**re:** Excavation, Grading and Drainage Plan Review  
Proposed Residential Development  
100 Steacie Drive, Ottawa, Ontario

**file:** PG5788-MEMO.03 Revision 3

**BRIGIL  
GRADING PLAN REVIEW  
100 STEACIE DRIVE**

Project		PG5788 - 100 Steacie Drive	
	Group		Section A - Static Analysis	
	Drawn By	PT	Company	Brigil
	Date	04/2026	File Name	Slope Stability Assessment

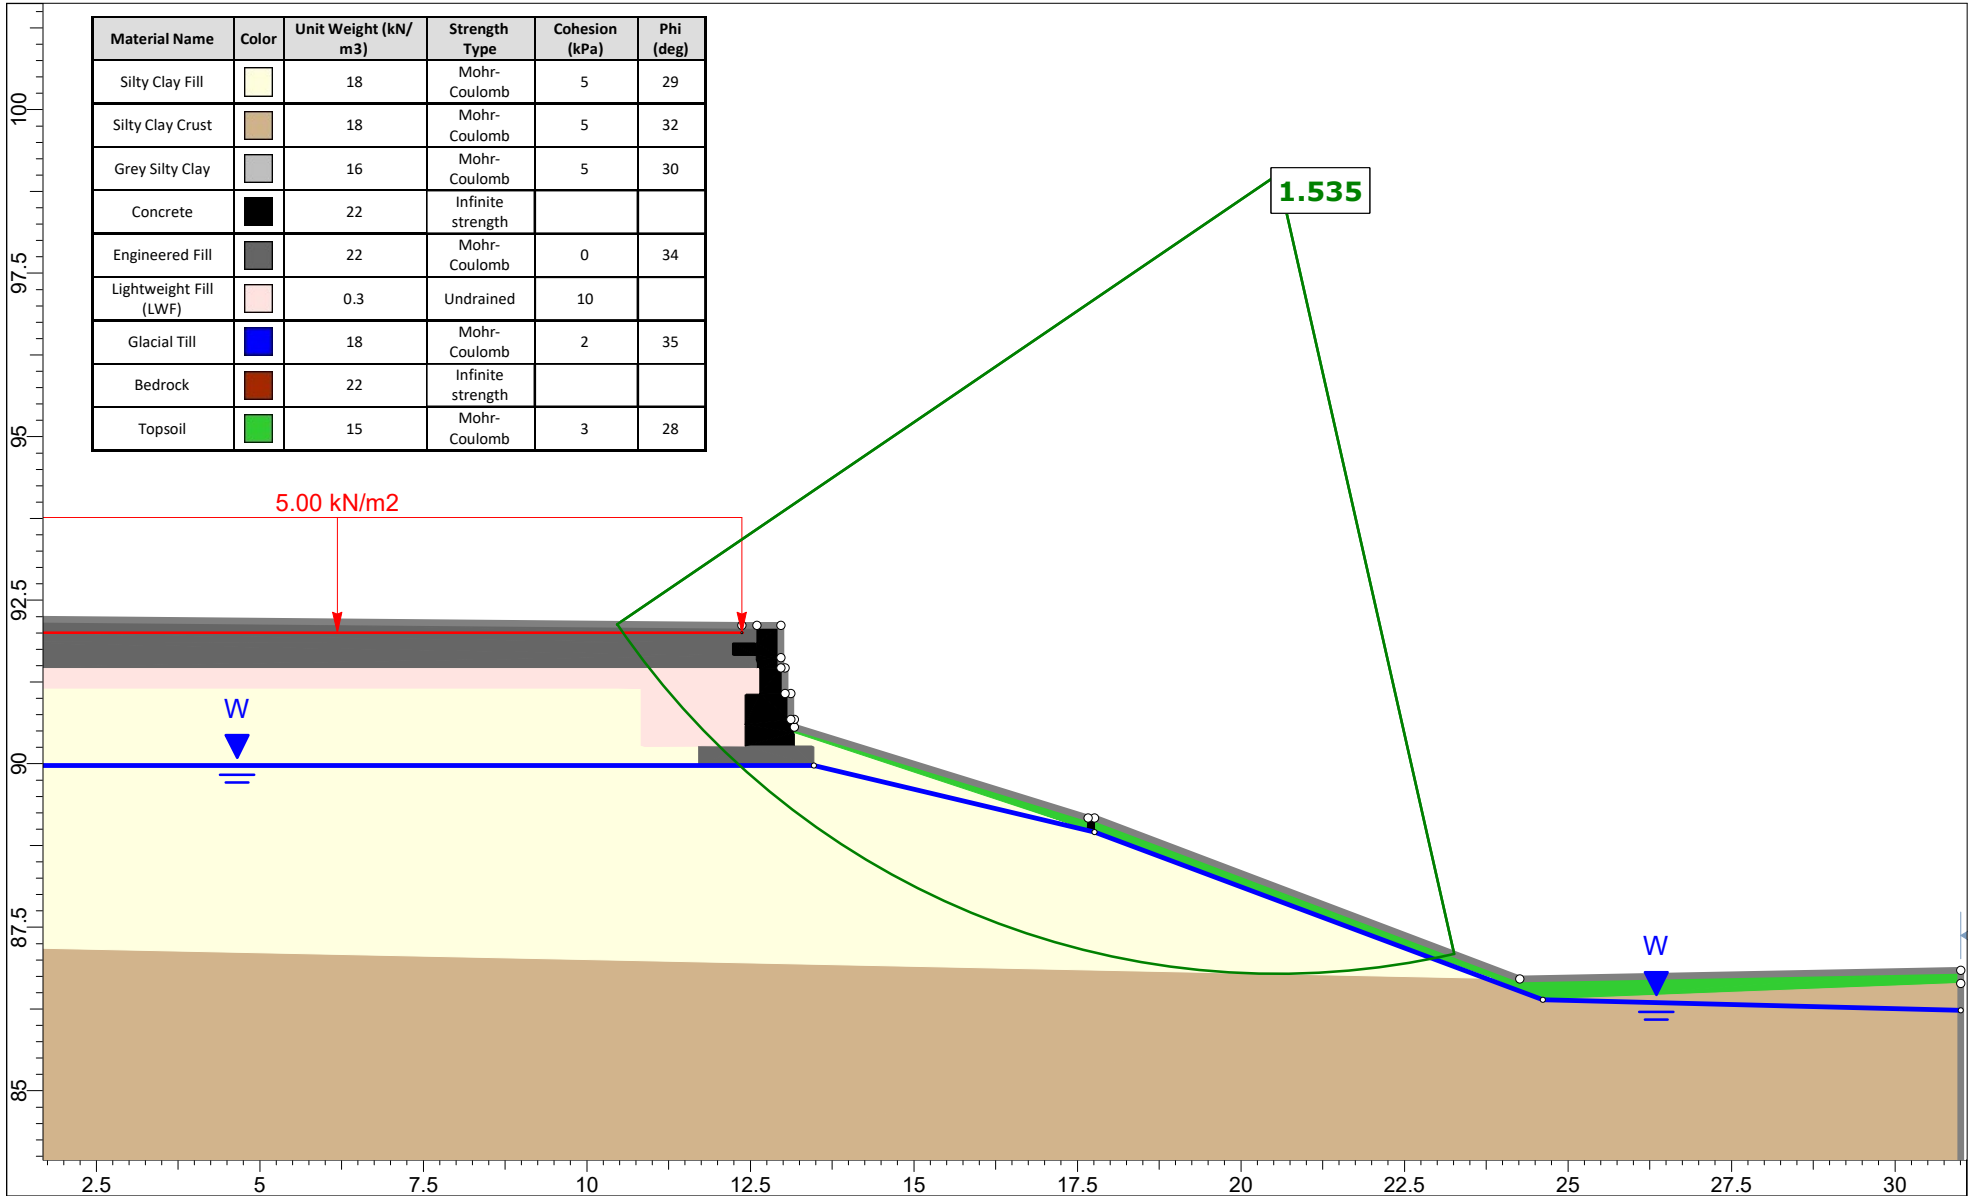
The static and seismic analysis results for slope cross-section A are presented in the figures attached below. In summary, the factor of safety for the slope was more than 1.5 under static conditions and more than 1.1 under seismic conditions.

**LIGHTWEIGHT FILL DETAIL**

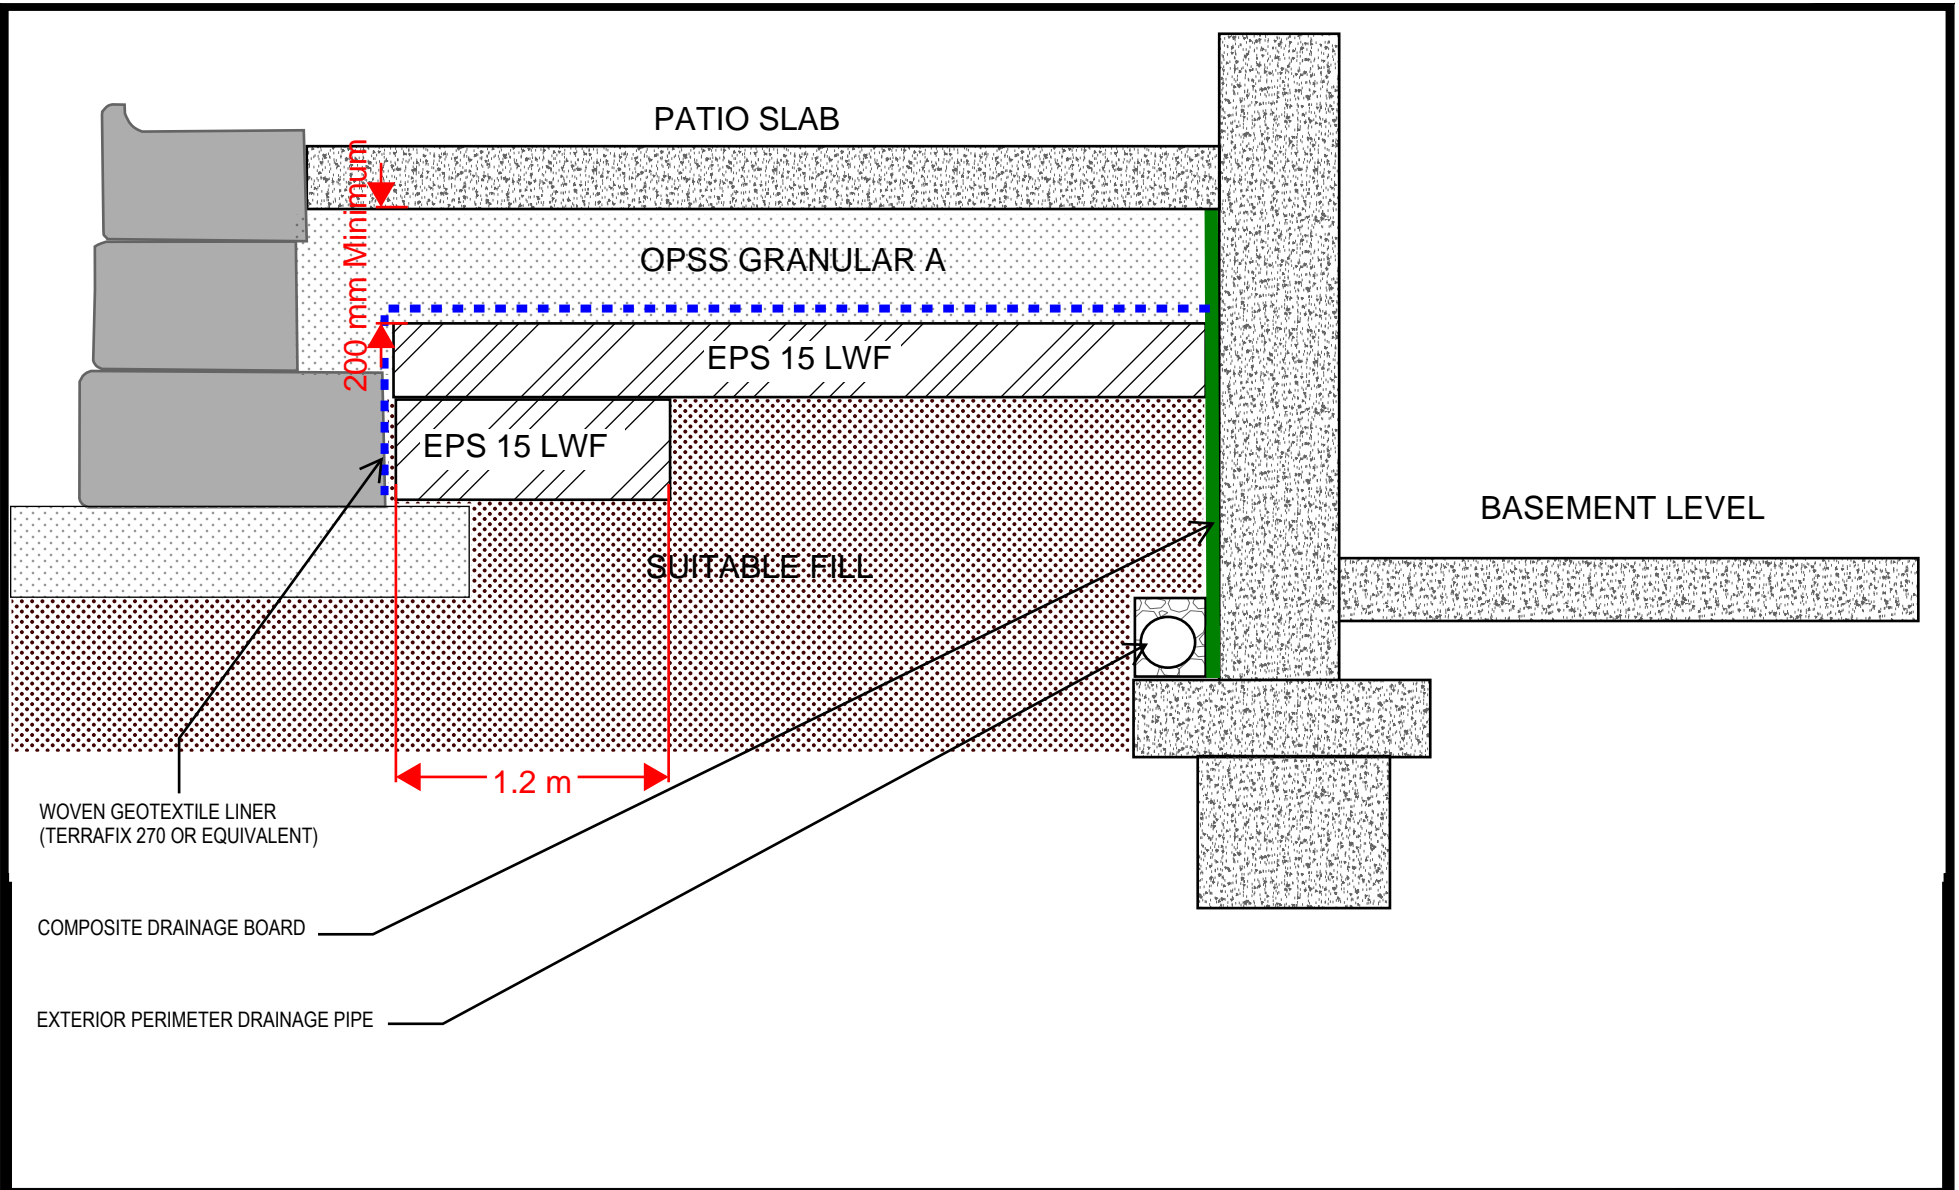
To mitigate the settlement in the landscaping areas, some lightweight (LWF) will be required surrounding the proposed retaining walls and the hardscaped areas located along the north and northeast side of the building. The LWF material should consist of EPS 15.

Reference should be made to the attached grading plan markup and LWF details attached below for the required LWF thickness within the respective areas.

It is not recommended to plant medium to large trees directly above the LWF EPS. The EPS should be covered with a polyethylene sheet and surrounded with a non-woven geotextile such as Terrafix 270R.

A minimum of 200 mm of OPSS Granular A should be placed above the LWF under the hardscaped areas and a minimum 200 mm of approved fill material and a minimum of 100 mm of topsoil should be placed under landscaped areas.
